| Device | XC864L-1FR |
| Marking/Step | AA |
| Package | PG-TSSOP-20 |

This Errata Sheet describes the deviations from the current user documentation. The module oriented classification and numbering system uses an ascending sequence over several derivatives, including already solved deviations. So gaps inside this enumeration can occur.

Figure 1

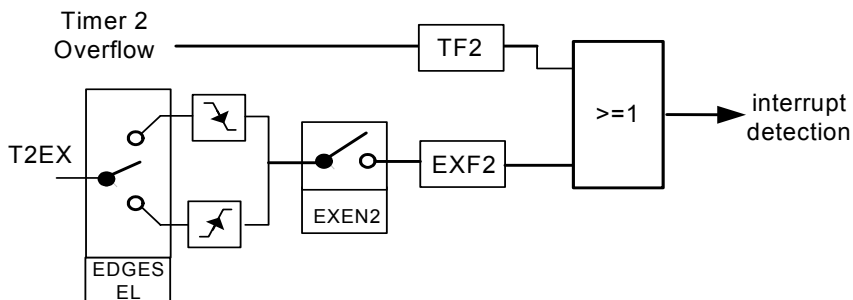
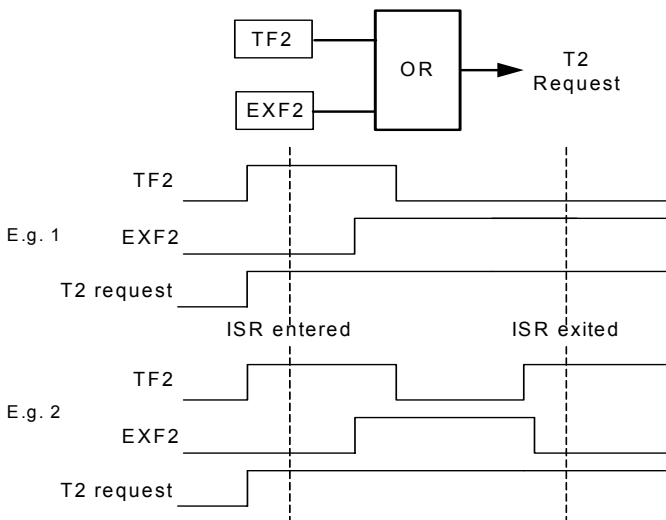
As illustrated in the simplified figure, the Timer 2 interrupt flags `TF2` and `EXF2` are combined as one interrupt request output. These flags are located within the Timer 2 kernel, with a single interrupt request line as output from the kernel.

Being of interrupt structure 2, the interrupt request of Timer 2 is detected on the rising edge of a positive pulse.

The problem is that it may occur at some point in the application, that any new Timer 2 interrupt request can no longer be detected after a return-from-interrupt (reti) due to service of earlier event(s). This happens when the following conditions are true:

1. Timer 2 events are serviced by interrupt (i.e. flags are checked and cleared only in the interrupt routine ISR),
2. Either TF2 or EXF2 is set at any one time throughout the ISR (even while the other is cleared) such that at least one of the flags is still set after reti, causing the Timer 2 request line, which is an OR-function of the two flags TF2 and EXF2, to remain set throughout the ISR and after reti.

There is no problem if EXF2 is not enabled by setting bit EXEN2 = 0 i.e. external events are disabled, or if bit DCEN = 1 in auto-reload mode.

Otherwise if EXF2 is enabled, while TF2 is always enabled when Timer 2 is running, there are two suggested workaround:

1. If other events of Timer 2 interrupt node (ET2) need not be enabled for interrupt, disable this interrupt node and use software polling of the flags instead.
2. Before return from interrupt, check again if TF2 or EXF2 is (still) set (due to new request since the last check). If so, jump and execute the ISR routine from start. Exit only when all flags are checked to be cleared. However, dummy interrupt of the node may occur after return from interrupt, and should be ignored. Another drawback is if Timer 2 events are occurring at high rate, the CPU may be 'stuck' in the service routine of the Timer 2 interrupt for a long time.

Figure 4 Counting sequence of T12 in center-aligned mode

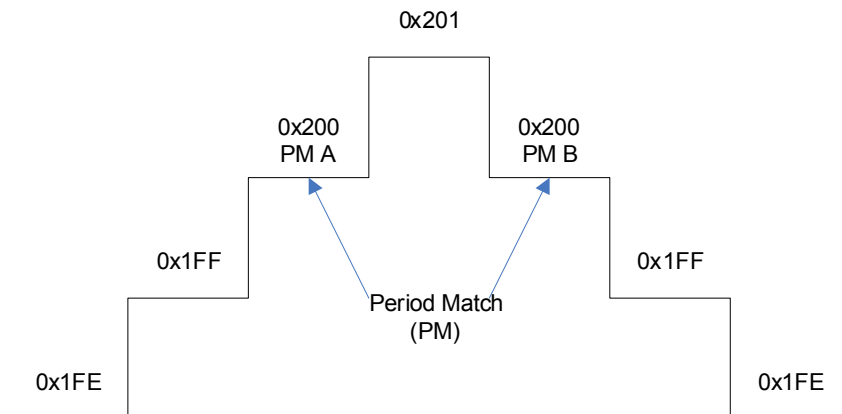
After detecting a period match (PM A) in centre-aligned mode, T12 counts down from PM + 1 as shown below:

This means a second PM event (PM B) will occur during the counting down. If ADC is triggered externally via ETRx2 (T12PM), it will be triggered twice in succession. Depending on how real-time the application code is running as well as the T12 count rate and ADC conversion rate, the application could observe two ADC interrupts - once at PM A and once at PM B.

To avoid triggering twice the ADC interrupts, it is suggested to use ETRx6 from multi-channel mode instead of ETRx2 as the trigger source for ADC. Additional initialization are as follows:

- Configure MCMCTR.SWSEL = 101_B (Transfer on T12 period match)
- Configure MCMCTR.SWSYN = 00_B (Direct transfer)
- Write to MCMOUTSTL = CF_H (To enable multi-Channel PWM pattern on CC6x and COUT6x)

Figure 5

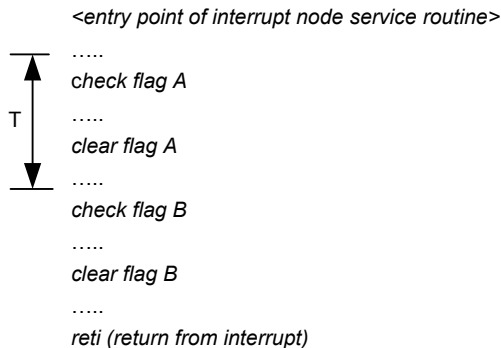
Consider the following interrupt service routine pseudo-code, and scenario where a interrupt source A event leads to interrupt request of the node and CPU vectors to the interrupt routine. Meanwhile, interrupt source B and its flag becomes active any time in the duration indicated by T:

In this case, flag B will be cleared as a standard procedure by the interrupt routine in the current service of the interrupt node. However, the pending interrupt request for the node remains activated after RETI, as it is only cleared by hardware when CPU acknowledge the interrupt and vectors to the interrupt routine.

This leads to following servicing of the interrupt node again, but potentially no active flag is found, i.e. dummy interrupt service. The point to note is that the interrupt source B is not lost, as it was actually serviced in the current service of the interrupt node.

The recommendation is to ignore these dummy interrupt vectoring.

Figure 6

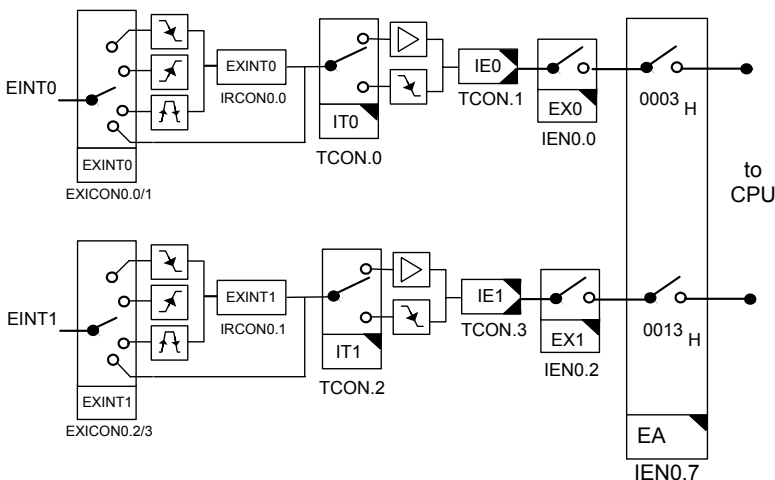
External interrupt 0 and 1 may individually be selected via respective bits (**EXINTx**) in **EXICON0** register, to request interrupt on falling edge, rising edge, both edges or to bypass the edge detection.

Edge detection is done in the system unit. If enabled, an active event will set the **EXINTx** flag and correspondingly set the **IEx** flag in **TCON**. It should be noted that after any external interrupt x event, flag **EXINTx** must be cleared. In case of falling edge as active event, this allows any future active event to be able to set the flag **IEx** as interrupt request. In case of low level as active event, this prevents unintended recurring triggering of interrupt request.

1. Flag `IEx` is cleared automatically by hardware when the interrupt is being vectored to.
2. Flag `EXINTx` has to be cleared by software.
3. Clearing one external interrupt x flag will not clear the other. Especially, clearing flag `EXINTx` will not clear the flag `IEx`. Being of interrupt structure 1, the flag `IEx` is the request polled by the CPU for interrupt servicing. Therefore user has to take care to clear the flag `IEx` before switching from SW polling method to enabling the external interrupt x node, to prevent potential dummy interrupt request.
4. Always clear both `EXINTx` and `IEx` flags before (if) changing the trigger select in `EXICON0` register.
